29th July 2022

**PITCH DEVELOPMENT, RADCLIFFE MOOR ROAD, LITTLE LEVER (APP. REF. 67658)
RESPONSE TO COMMENTS ON THE HYDROLOGICAL ASSESSMENT BY BURY COUNCIL PARKS AND
COUNTRYSIDE DRAFT 1 (UNDATED – RECEIVED 14.06.2022)**

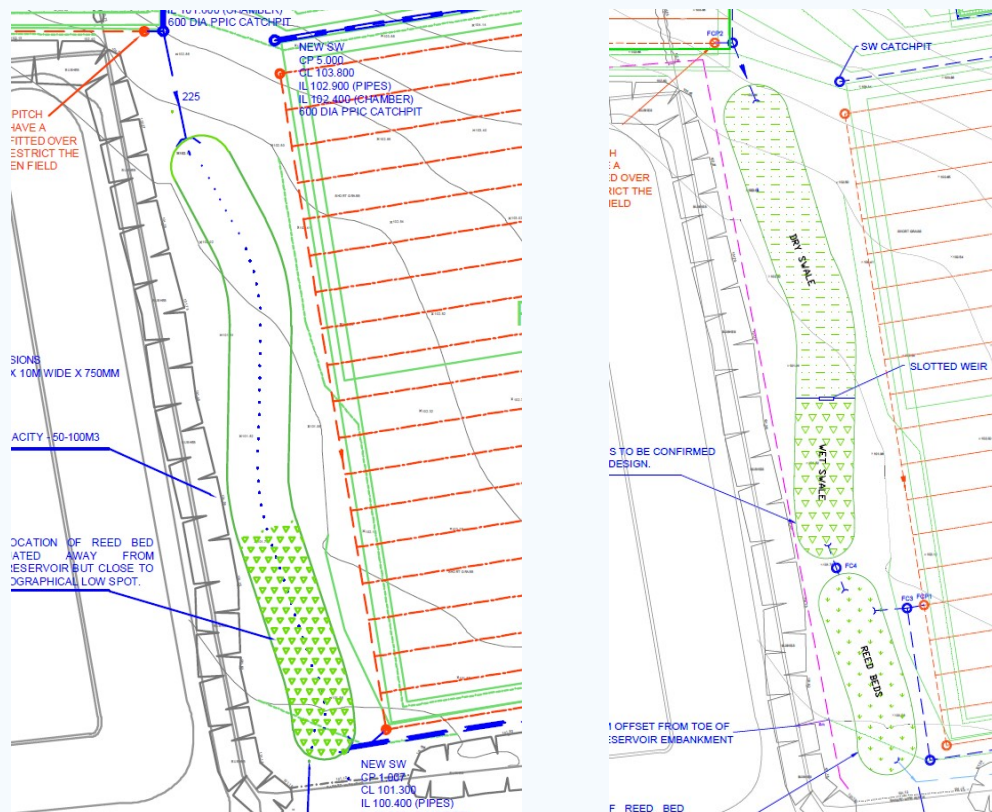
The design of the combined reed bed/swail is flawed.

It needs to be in two parts.

4.2 The report explains that the swale and reedbed are in two parts. This is shown in the extract below from the Hydrological Assessment drainage strategy plan – both the previous version on the left and the updated plan on the right which shows more detail.

4.3 In fact there are three distinctly different parts as the swale is a 'dry swale' in the upper portion, then becomes a 'wet swale' and then this swale discharges into the reedbed. The detail of the interface between the dry swale, wet swale and reedbed are a matter of detailed design but I would envisage a slotted weir between the dry and wet swale to make landscape maintenance easier and then a spill weir from the wet swale to maintain a permanent water level in the base with a piped connection into the reedbed.

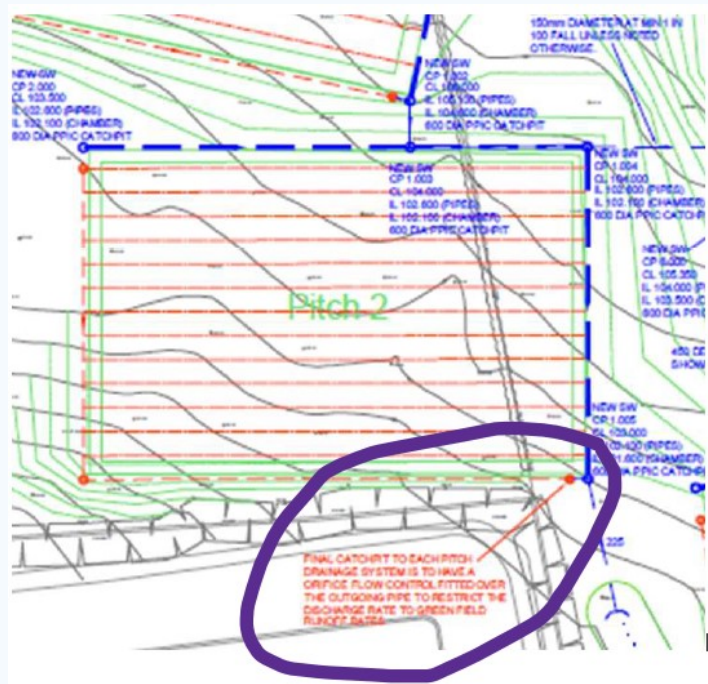
The suggestion that the leaching of fertilizers herbicides and other chemicals might be controlled by conditions is unsatisfactory.

It is similar to having an unbudded fuel tank and trying to prevent spillages by having procedures in place rather than a bund. The hierarchy should be to stop the spillages in the first place by engineering means (the bund) and have procedures in place as well.

In this case the contaminated water needs to be treated within the site and best practice observed in the maintenance of the pitches.

5.2 Regarding the seven points above, the risk of nutrient leaching can be reduced using slow and controlled release fertilisers. Organic based feeds also act in a slow-release manner as well as improving the physical condition of the soil. Controlled release fertilisers are especially effective in reducing nitrogen leach in the form of nitrate. Phosphate is very immobile through even sand-based soils and the increased risk of leaching would be more associated with potassium. If required, the cation exchange capacity of the upper sandier topsoil could be increased without compromising drainage potential by adding Zeolite. In addition, there is a product called LeoZeo which is zeolite based, but also contains an organic matter source. Additional details of specific products can be provided if required.

Other measures that can be taken to reduce leaching potential are to ensure balanced nutrient application so that nitrogen uptake by the grass plants is optimised. Undertaking a good aeration regime including verti-draining will help to improve rooting depth which will increase nutrient uptake and reduce nutrient leaching potential. The fact that sand has been added to the topsoil and that there is a drainage system will mean that the risk of surface water run-off will be reduced. It should also be noted that the amount of sand through the soil profile will reduce with depth. It will only be approximately the top 100mm depth of the topsoil profile which will have a higher sand content. Any leached nutrients will be captured by the underlying heavier clay-based topsoil present beneath the shallow sandier upper layer.

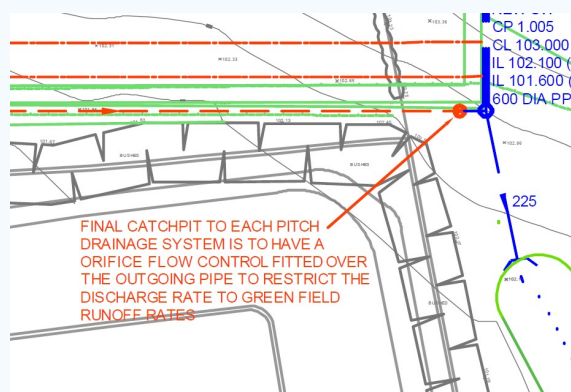
The flow control system will not work as drawn in Figure 9. Constraining the flow at the point indicated without the water having elsewhere to go will cause the manhole to discharge due to the head of water from Pitch 3 and Pitch 4 which are both higher than Pitch 2.

6.1 What is being described in the comment is not what is being proposed. What is being proposed is an orifice flow control to 'each pitch' on the final catchpit. This creates a cascading effect specifically so that one pitch does not hydraulically impact on the subsequent lower pitches. The note encircled specifically states this – see the note below which I have increased in size for clarity.

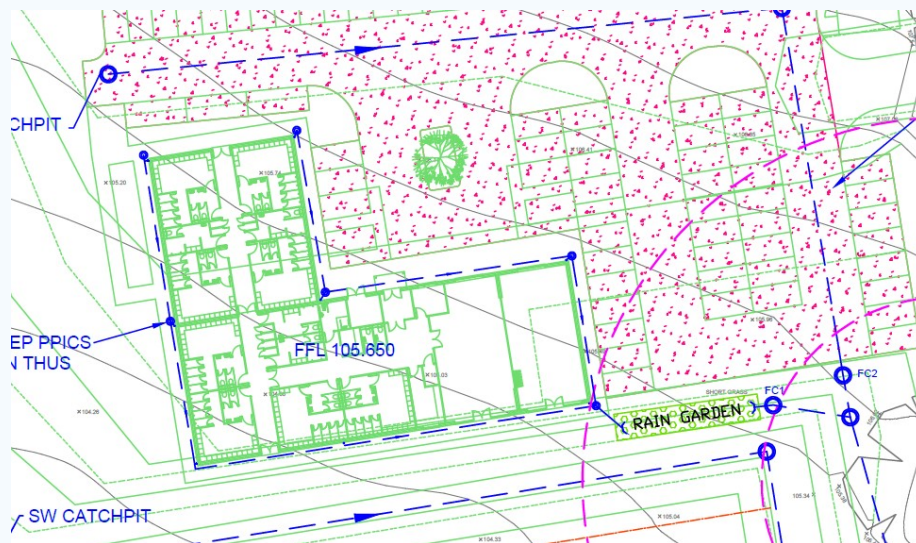
It appears to be impervious tarmac and concrete paving. How does the water enter the proposed permeable fill forming the sub-base soakaway. What provision is there for silt/oil traps?

Presumably this design is flawed as the subbase will silt up over time and stop acting as a soak away?

7.2 It is not impervious tarmac and concrete paving; I am unsure where this appears? The report and drawing corroborate that the paving will be permeable with a type 3 sub-base. Water enters the permeable sub-base depending on the specific finish proposed which may be a porous asphalt of something similar, either way flow is through voids in the structural make-up. The sub-base should not be described as a 'soakaway' as it is designed for zero infiltration as this is what the ground investigation information tells us. There may be some incidental infiltration occurring but this is not a soakaway. The outfall is throttled and discharge controlled before flow goes into the dry swale and then the reed bed. There is no provision for an oil trap or interceptor as they are not required, filtration (not infiltration) occurs within the sub-base of the car park and as water filters through the road construction there is significant water quality improvement including bacterial digestion of oils. Very little silt should enter the system via the surface but any that does will be captured within the subbase or the catchpit into which this connects where the flow control is located.

7.3 This presumption is incorrect, principally because the car park is not a soakaway. Some incidental infiltration may occur but this is not the primary purpose of the structure (see 7.2). It should also be noted that in addition to the perforated pipe system within the car park sub-base
